Access Compliance Report Public Rights-of-Way (Curb Ramps)

Main Street: KEEGAN_WAY Cross Street: ETHELBEE_WAY Location: NW

ADA ID: RPAT210930085101 Ramp Type: Type 1 - Perpendicular Diagonal Initial Pass/Fail: Fail Overall Compliance: No Severity Score: 2

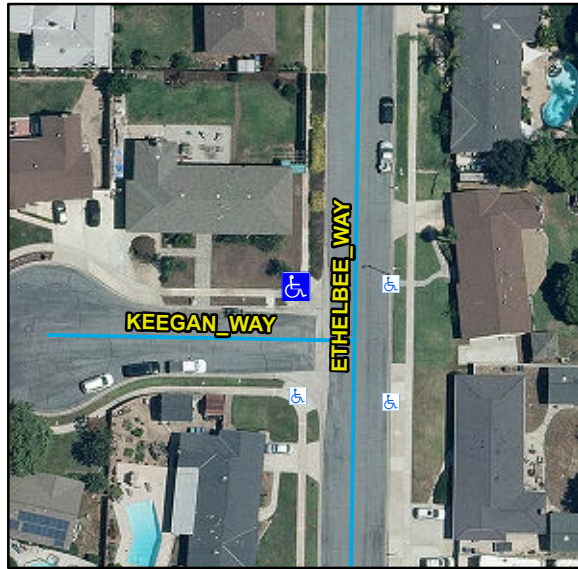
R304.2.2, R304.5.3, STD 1115

Remove & Replace Curb Ramp With Two New Directional Ramps or Equivalent.
